**Town of Breckenridge**  
**Planning Commission Agenda**  
Tuesday, May 3, 2011  
Breckenridge Council Chambers  
150 Ski Hill Road

- Project Manager:** Michael Mosher, Planner III
- Date:** April 21, 2011 (for May 3, 2011 Meeting)
- Subject:** Columbia Lode Subdivision PC#2011005 (Final Hearing)

## Planning Commission Staff Report

COLUMBIA LODGE SUBDIVISION  
OVERLOT GRADING, DRAINAGE  
AND EROSION CONTROL PLAN

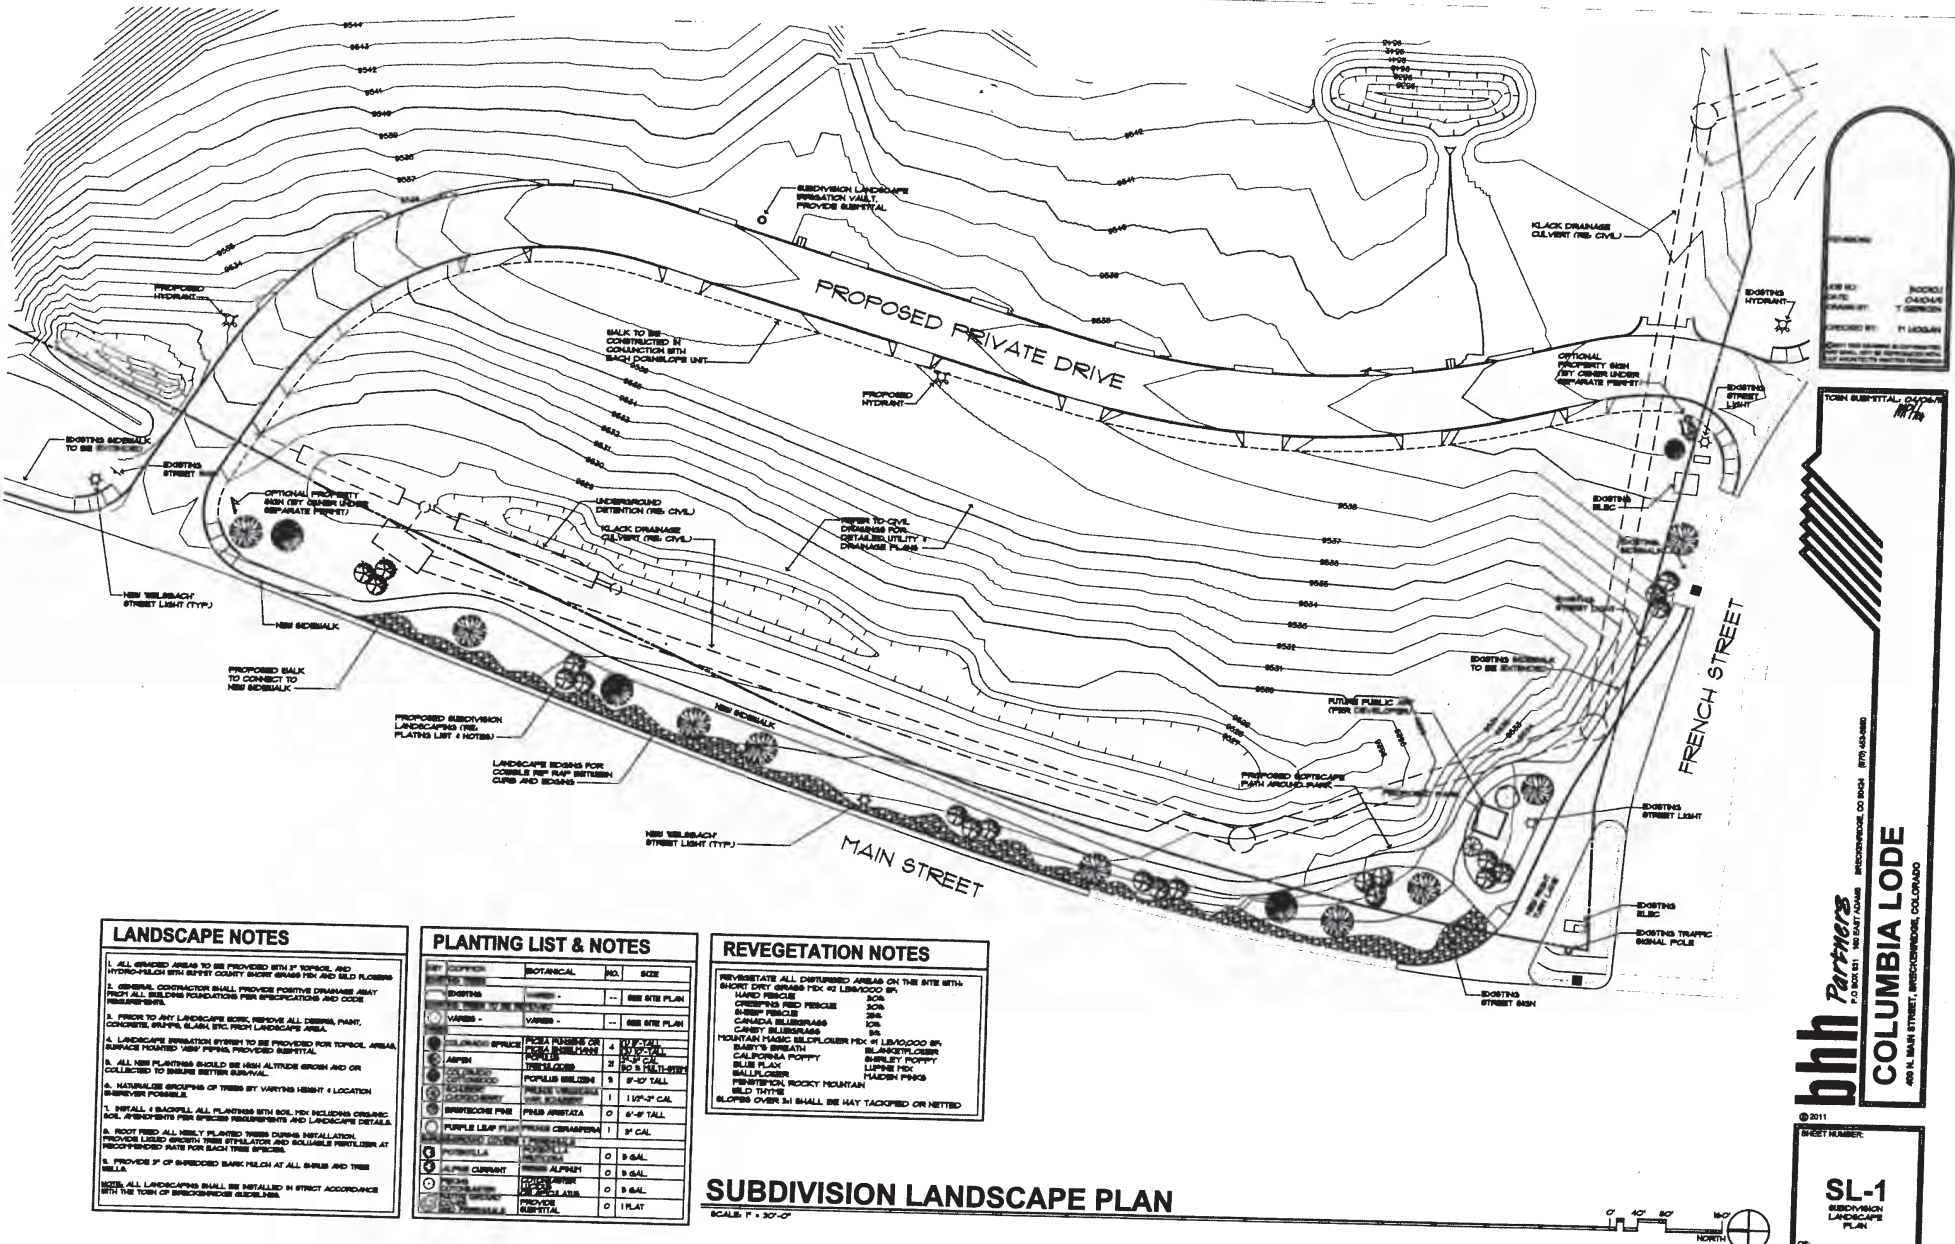
As described in the master plan documents, the existing BBC site area will have fill dirt added to bring the grade to a slope to meet the undisturbed hillside to the east. The submitted Subdivision plans show this on Sheet 3. In addition to the grading plans, there are notes indicating that the grading will be performed over time with the beginning being planned in 2011. The extent of these improvements is shown to be “up to 10 years”.

New landscaping is being proposed along the two abutting Right of Ways, Main Street and French Street. Though the drawings indicate that 2-inches of topsoil is to be placed over disturbed areas, we are asking for 3-inches of top soil because of the steeper grades. These plantings will be installed with the initial subdivision improvements (Deep utilities, drainage systems and the private drive). The plans show 4 Colorado Spruce 8-10 feet tall, 21 Aspen 2-3 inch caliper, 9 Cottonwoods 8-10 feet tall, 1 Chokecherry 1-1/2-2 inch caliper, and 1 Purple leaf Plum 3 inch caliper. Staff has no concerns with the proposed plantings. We welcome any comment from the Planning Commission.

OPT STAIR

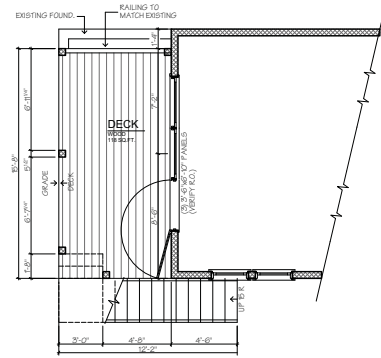
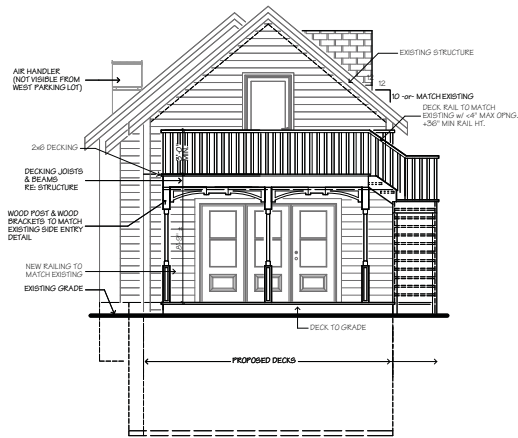
On the west facing façade of the building, the drawings show two options (see attached drawings).

Of the two options presented, Staff would prefer Option 2 since the majority of the stair would be located between buildings and less visible from the west. Secondly, we would prefer to see the width of the deck reduced to be subordinate to the deck below. We welcome any Commissioner comment.

1. We would like the Commission to comment on the two options for the exterior stairs and deck. Does the Commission believe negative points should be awarded for the design?
2. Does the Commission agree that the design of the gable dormer should be modified to avoid removal of historic fabric?
3. Does the Commission support the landmarking findings that Staff has presented?
